Reply to Office Action of August 6, 2008

**AMENDMENTS TO THE DRAWINGS**

#### Docket No.: 593458001US

### **REMARKS**

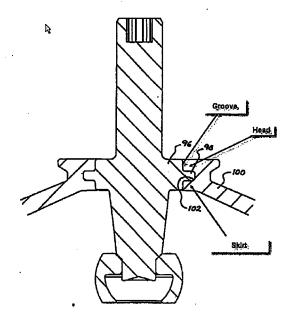
The combination of the Background Information and Almgren does not support a Section 103 rejection of claim 1 because, among other reasons, Almgren teaches away from being combined with the teachings of the Background Information. In the August 6 Office Action, the Examiner relied upon Almgren's Figure 10 (reproduced below) for the disclosure of a first edge having a skirt lying on the lip upstanding from the groove.

The Examiner corresponded an upper portion of Almgren's groove 102 to the head, and a lower portion of the groove 102 to the skirt in claim 1. However, as discussed during the December 29, 2008 telephone interview, modifying the ball joint of the Background Information with Almgren's boot 100 may render the ball joint of the of the Background Information inoperable. The Background Information discloses that the head of the ball

joint is free to ride in the groove during operation. In contrast, Almgren's boot 100, as an alternative embodiment of the boot 20 of Almgren's Figure 9, is held in place by a retaining ring 94 relative to the stem 18, so the upper portion of the boot 100 is not free to ride at all relative to the stem 18. As a result, by replacing the head 107 of the ball joint in the Background Information with Almgren's boot 100, the ball joint would fail to function because the rod and/or the ball 102 would not be able to rotate relative to the seal 104.
